## ADDENDUM #5

**Western Slope Food Bank of the Rockies**  
698 Long Acre Drive

**Bid Package #4 – Above Ground**

September 10, 2021

ADDENDUM #5 09/10/2021

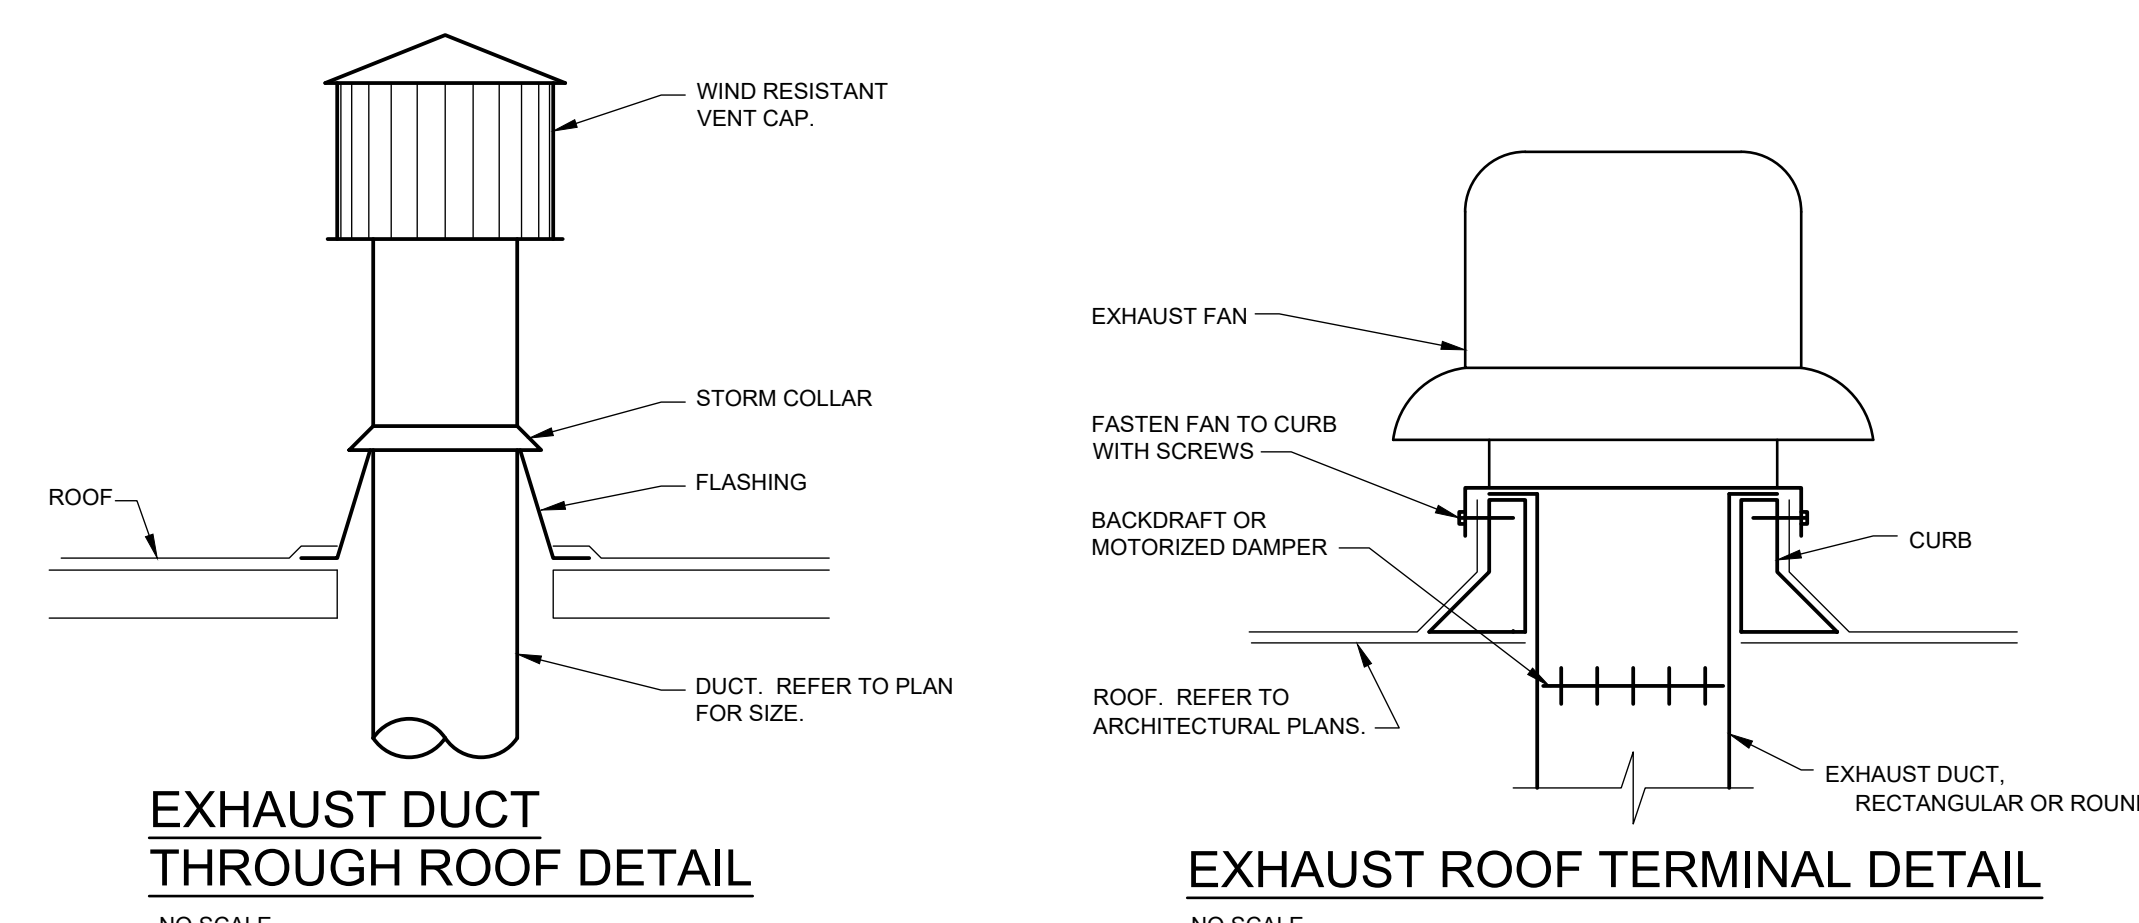
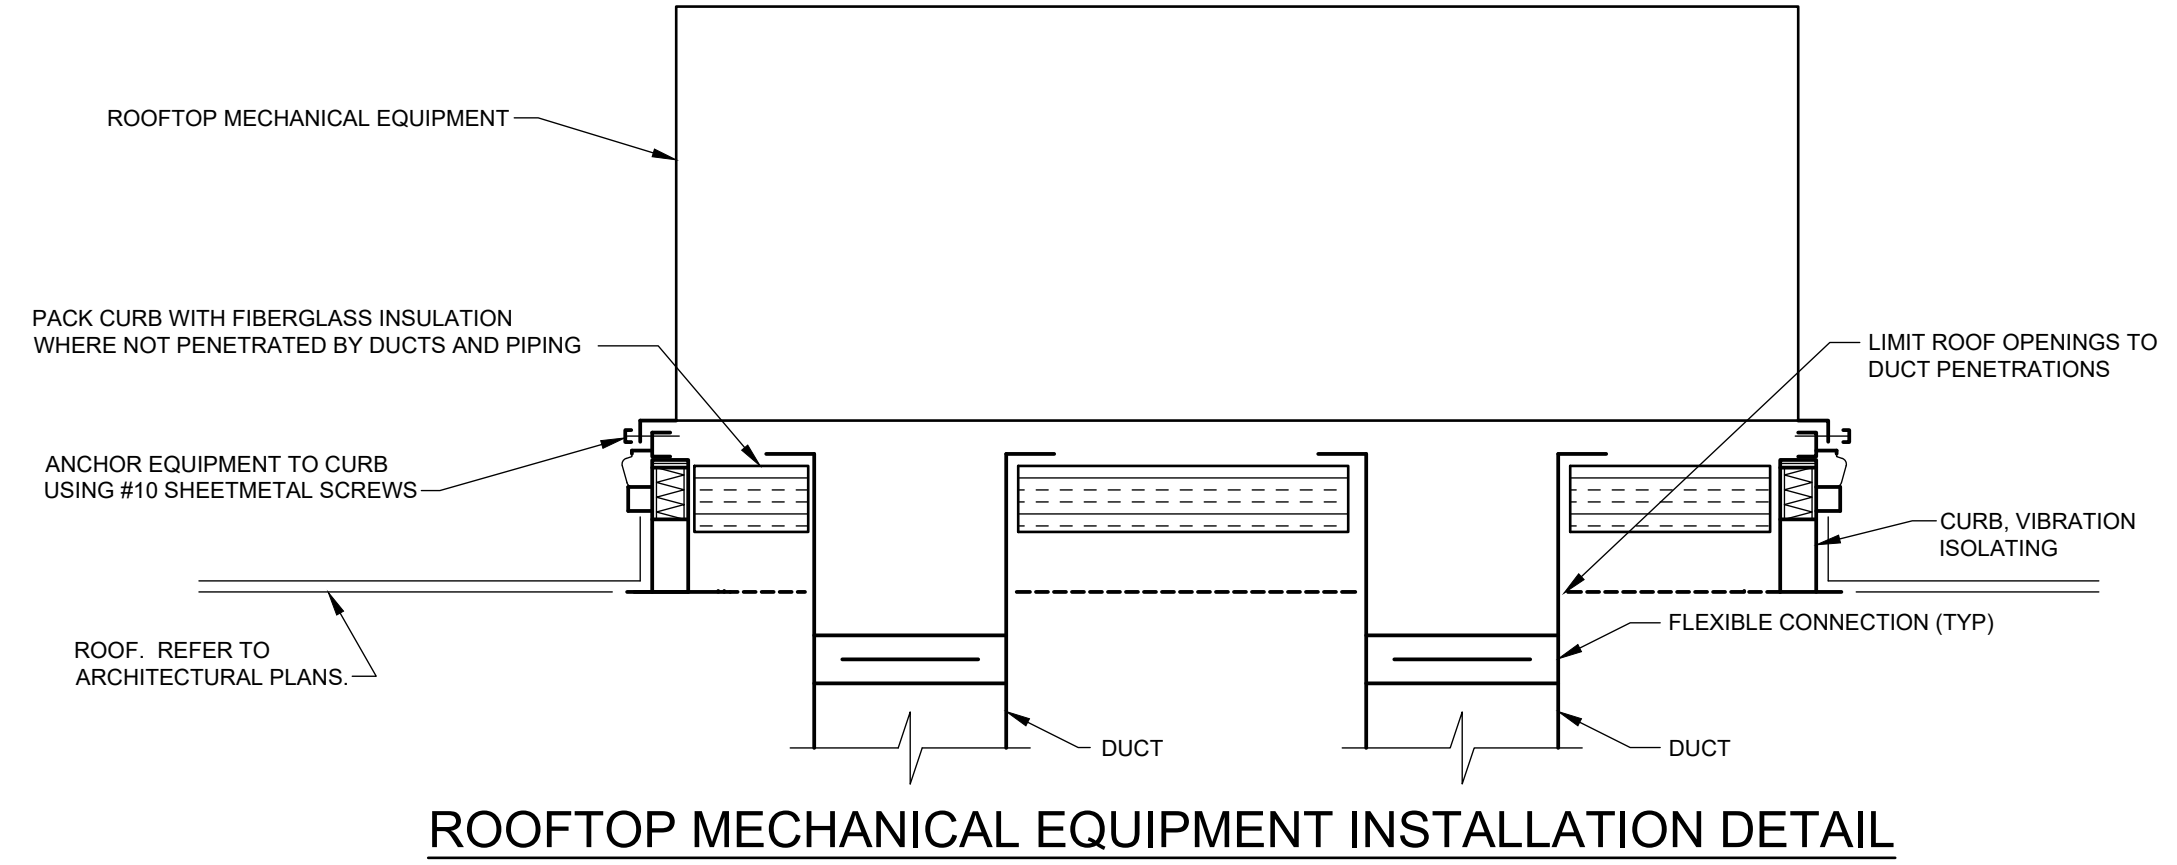
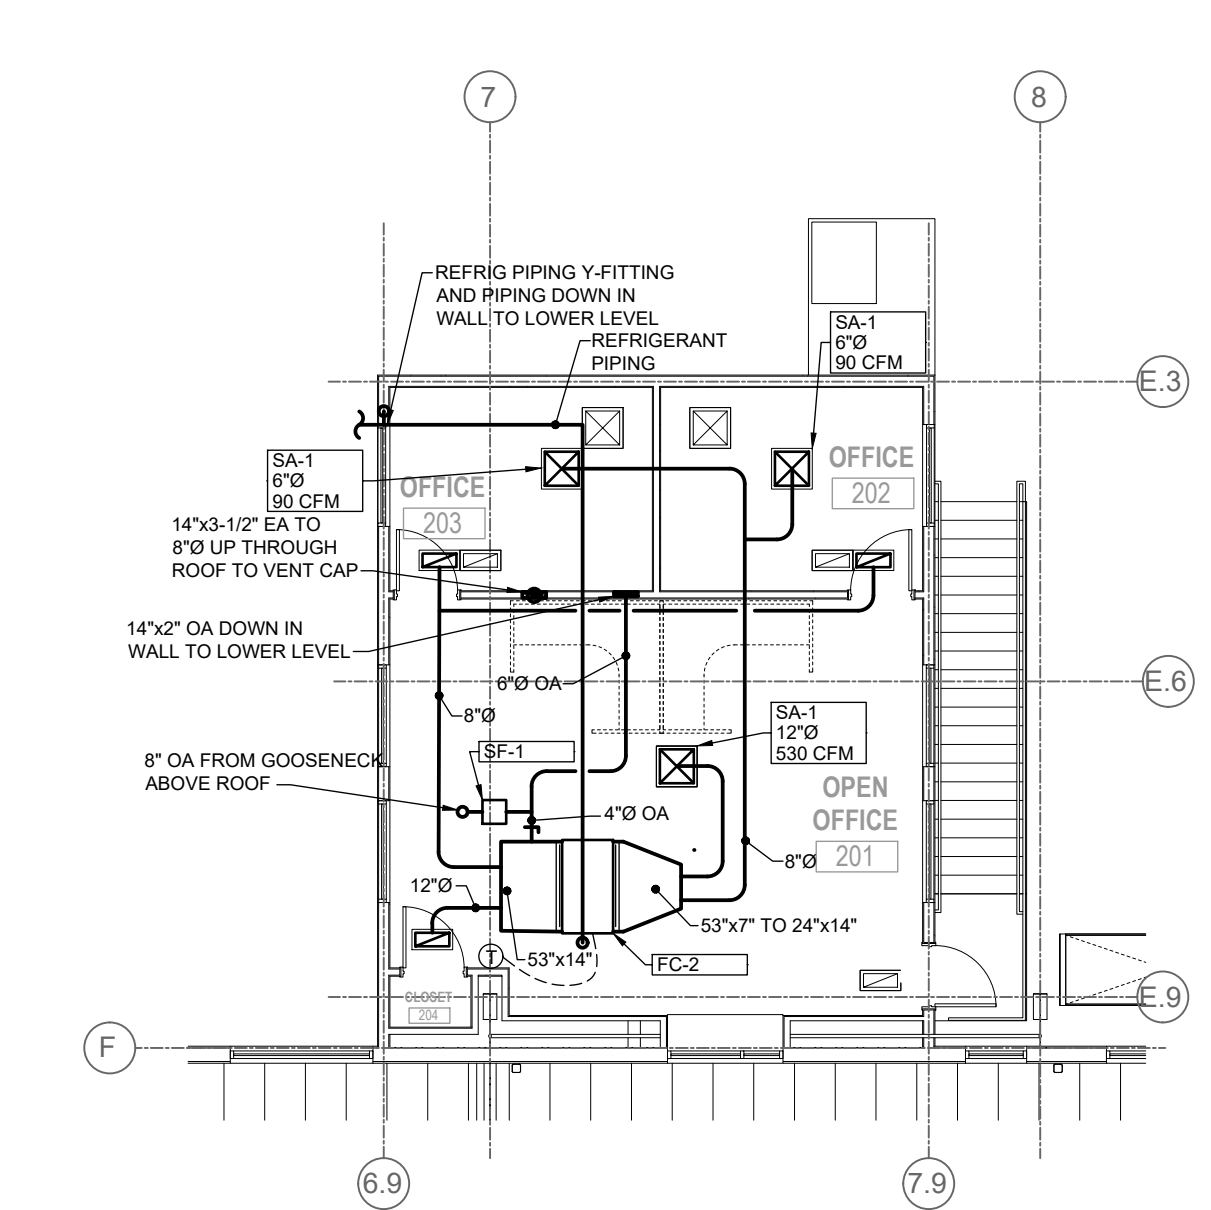
- ADD5-19 Sheet M101 Main Level Mechanical Plan - West & Second Floor Office: Delete sheet and replace with attached reissued sheet M101.
- ADD5-20 Sheet M201 Mechanical Details & Legend: Add Dehydrator Ductwork Details per attached reissued sheet M201.
